Historic Preservation Commission Meeting

January 07, 2026

LOT 51 - BLUE CRAB PRIVATE
RESIDENCE

Cover letter addressing plan review comments for COFA-09-25-019927
Lot 51,4 Blue Crab Road – Tabby Roads

3 TYP. 8/12 REAR UPPER PORCH EAVE DETAIL
A5.1 1" = 1'-0"

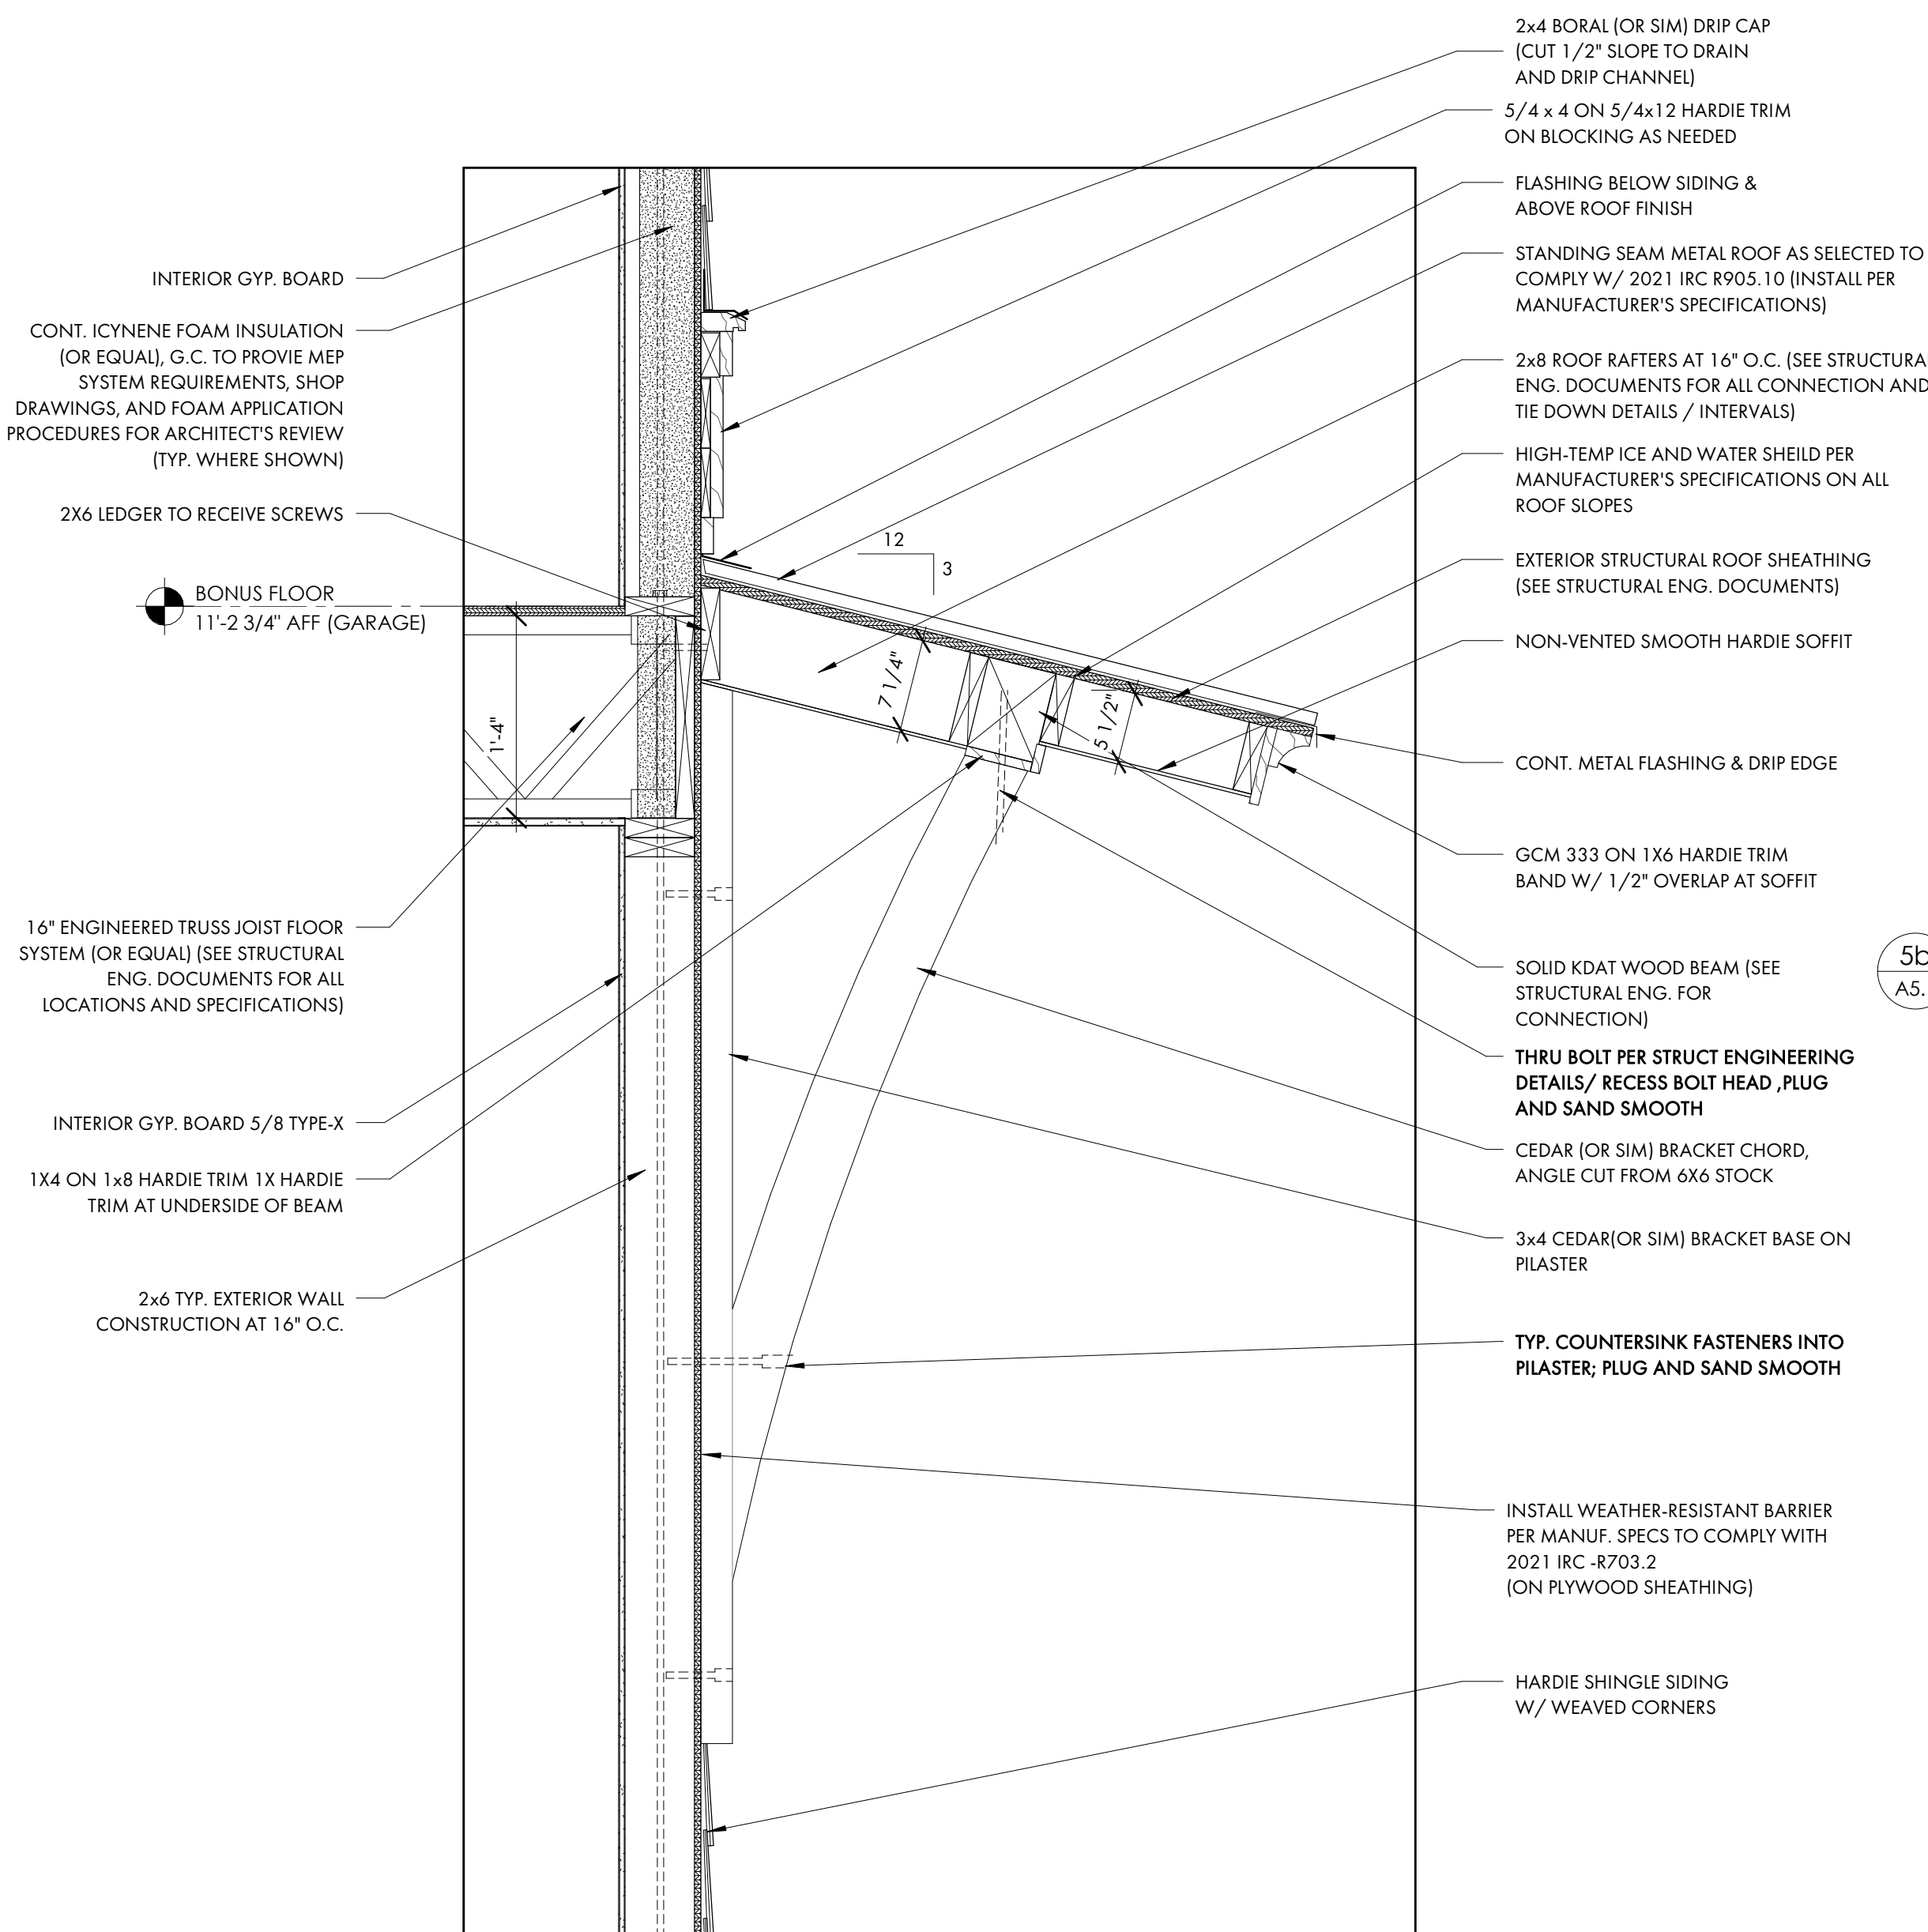
- **Please see detail sheet A5.0 clarifying the porch fascia details and identity of the porch ceiling material**
13. Second Concept Plan Review: Given the number of comments, a second Concept Plan review will be required.

We have updated the garage water table detail to suggest a 5/4x6 versus 5/4 x 4 trim band to match the main house. See sheet A5.1
